Re: NORTHEAST NUCLEAR ENERGY COMPANY, Millstone Nuclear
Power Station, Unit No. 2, Docket No. 50-336-OLA
(Spent Fuel Pool Design)

Millstone Nuclear Power Station, Unit No. 2
Proposed Revision to Technical Specifications
Spent Fuel Pool Modifications

Proposed Revision to Technical Specifications
Spent Fuel Pool Modifications

Marked Up Pages of Technical Specifications

FIGURE 3.9 - MINIMUM REQUIRED FUEL ASSEMBLY EXPOSURE AS A FUNCTION OF INITIAL ENRICHMENT TO PERMIT STORAGE IN REGION C

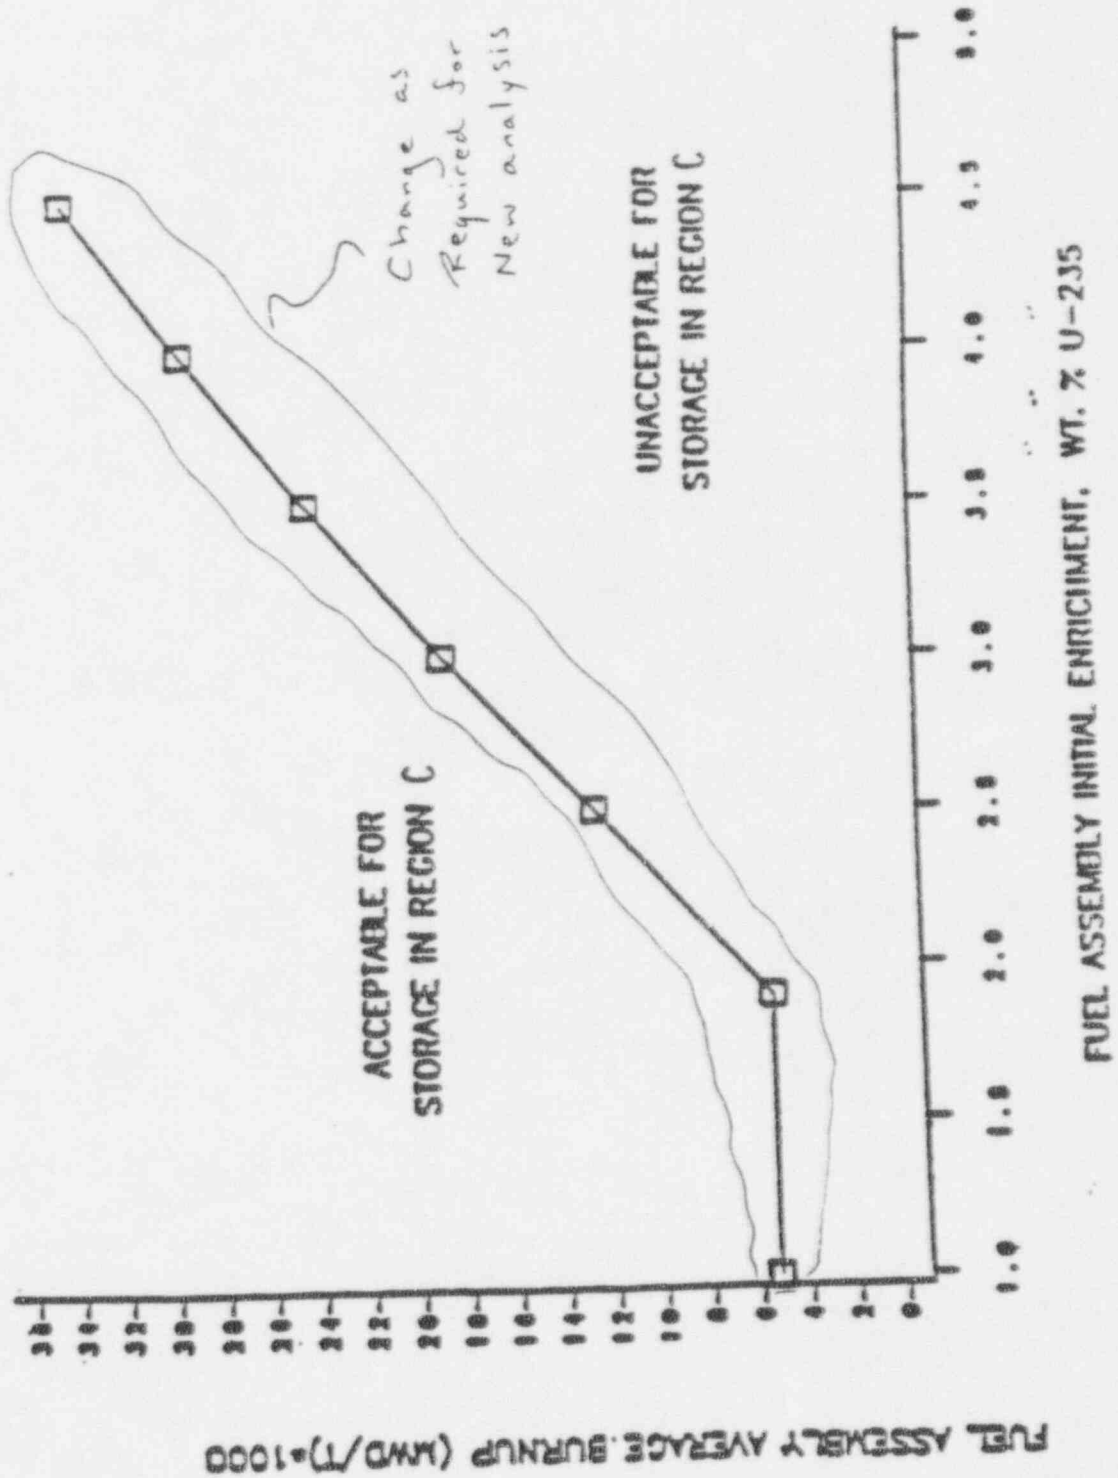
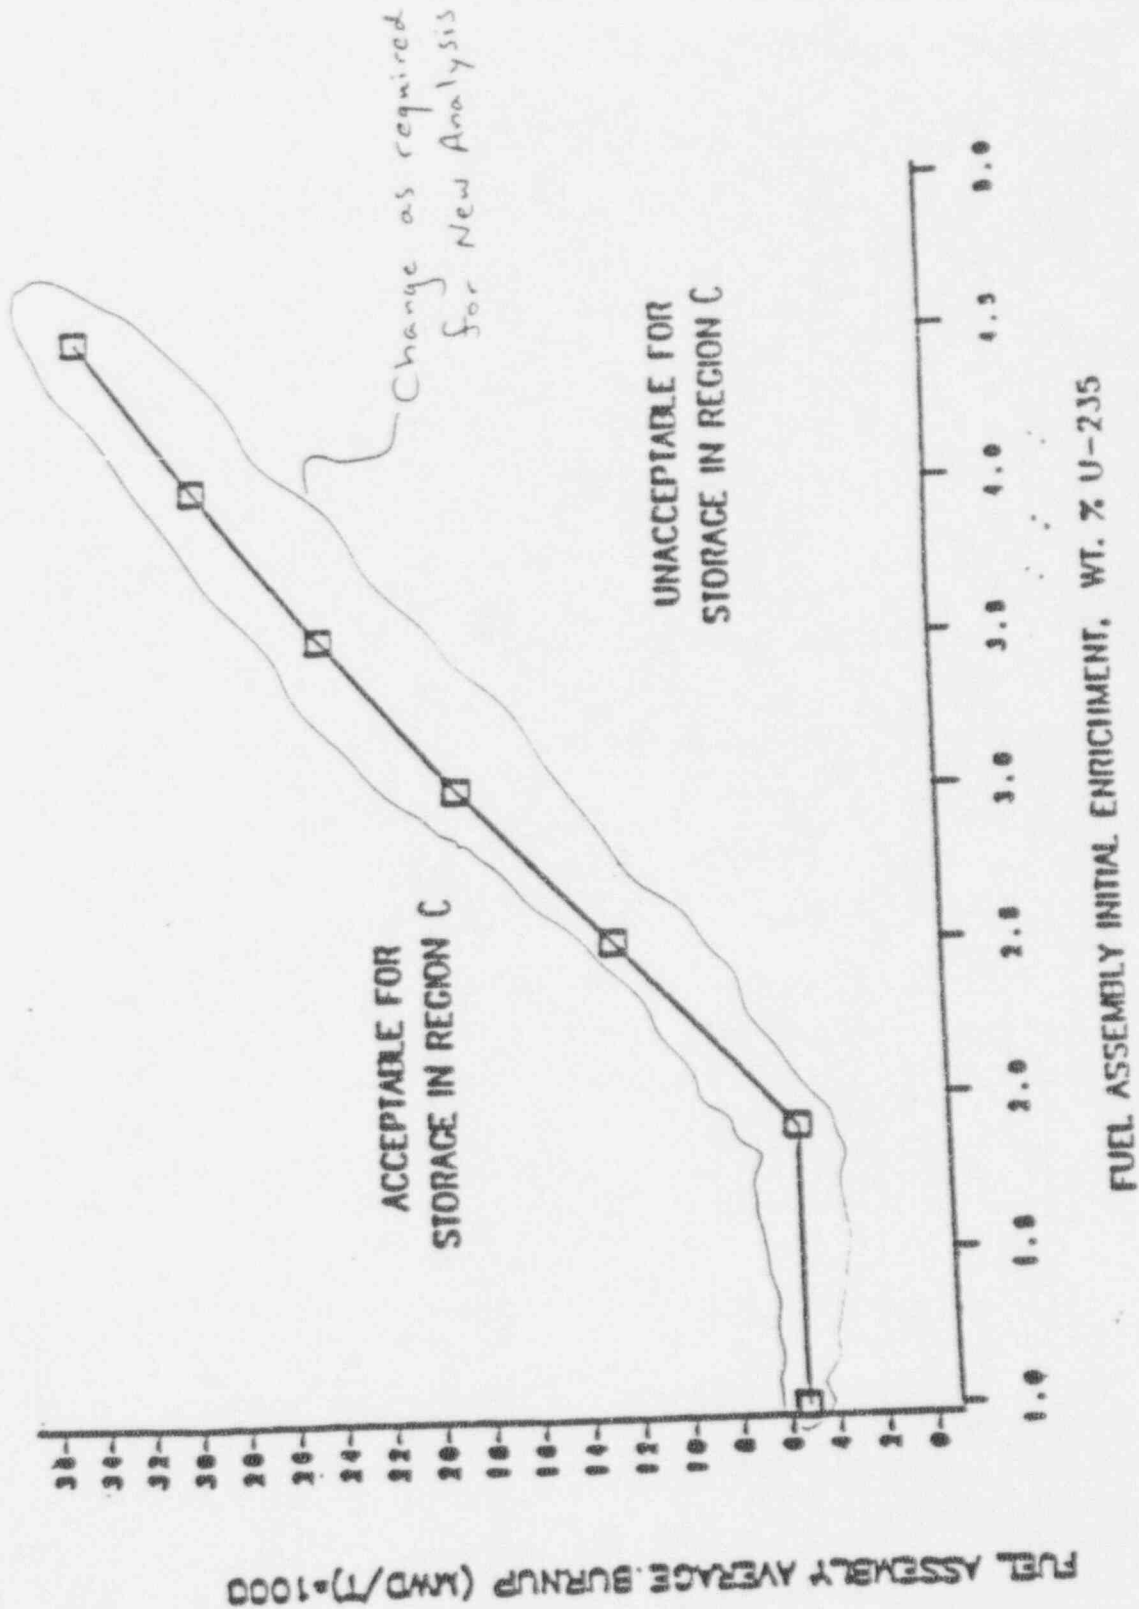
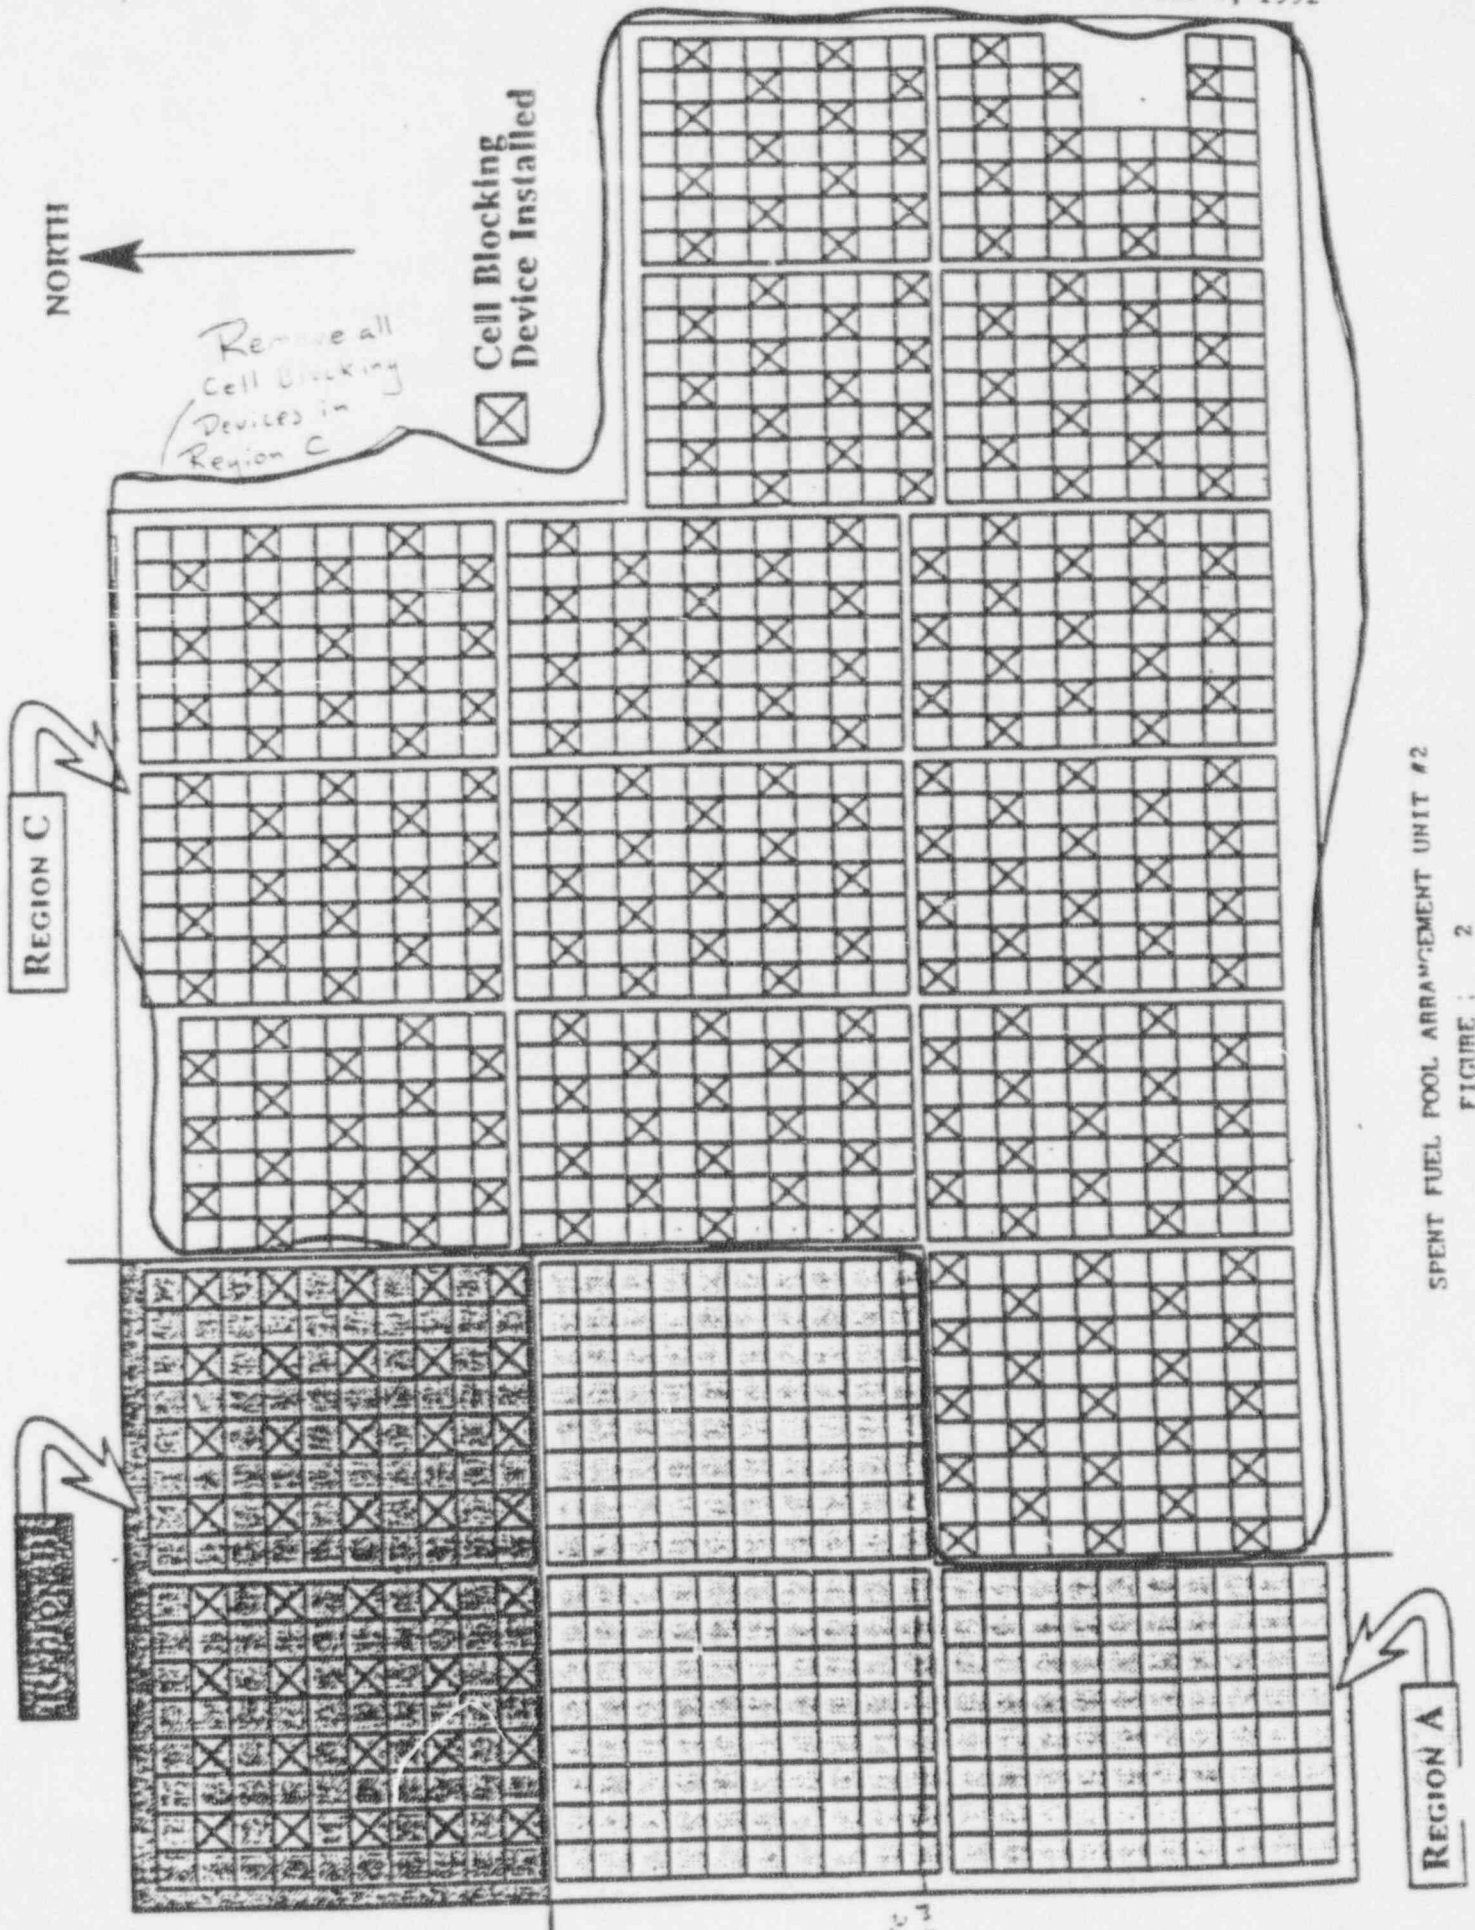
Figure 3.9-1, "Minimum Required Fuel Assembly Exposure as a Function of Initial Enrichment to Permit Storage in Region C," on page 3/4 9-23, is being changed to Figure 3.9-1a, "Minimum Required Fuel Assembly Exposure as a Function of Initial Enrichment to Permit Storage in Region C," to reflect the non-poisoned fuel assemblies to be stored in Region C; and Figure 3.9-1b, "Minimum Required Fuel Assembly Exposure as a Function of Initial Enrichment to Permit Storage in Region C with Poison Pins Installed," is being added as page 3/4 9-23a to reflect the poisoned fuel assemblies to be stored in Region C.

Figure 3.9-2, "Spent Fuel Pool Arrangement Unit #2," on page 3/4 9-24 is being changed to remove the cell blocking devices from Region C and to correct a typographical error in Region A.

FIGURE 3.9-1A MINIMUM REQUIRED FUEL ASSEMBLY EXPOSURE AS A FUNCTION OF INITIAL ENRICHMENT TO PERMIT STORAGE IN REGION C

FIGURE 3.9-1B MINIMUM REQUIRED FUEL ASSEMBLY EXPOSURE AS A FUNCTION OF INITIAL ENRICHMENT TO PERMIT STORAGE IN REGION C WITH POISON PINS INSTALLED
